## TECHNICAL SERVICE BULLETIN

### 1.5L GTDI - Illuminated Malfunction Indicator Lamp (MIL) - Diagnostic Trouble Code (DTC) P051B - Built On Or Before 1-Feb-2017

**17-2236**

Ford 2017 Escape
---------------------

Figure 1

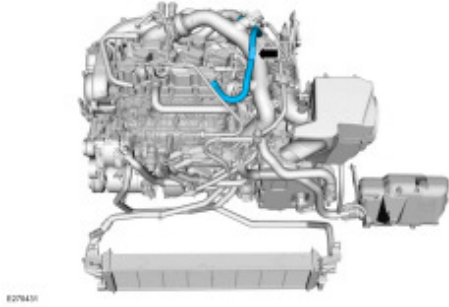
- Check the vehicle build date. Was the vehicle built on or before 1-Feb-2017?
  - Yes - proceed to Step 2.
  - No - this article does not apply. Refer to the Powertrain Control/Emissions Diagnosis (PC/ED) manual for normal diagnostics.
- Connect the Ford Integrated Diagnostic System (IDS) service tool or Ford J2534 Diagnostic Software (FJDS) to the data link connector (DLC). Check for DTCs. Is P051B stored in the powertrain control module (PCM)?
  - Yes - proceed to Step 3.
  - No - this article does not apply. Refer to the Powertrain Control/Emissions Diagnosis (PC/ED) manual for normal diagnostics.
- Remove cowl panel. Refer to Workshop Manual (WSM), Section 501-02.
- Remove and replace the crankcase pressure sensor/tube assembly. (Figure 1)

**5. To install, reverse the removal procedure.**
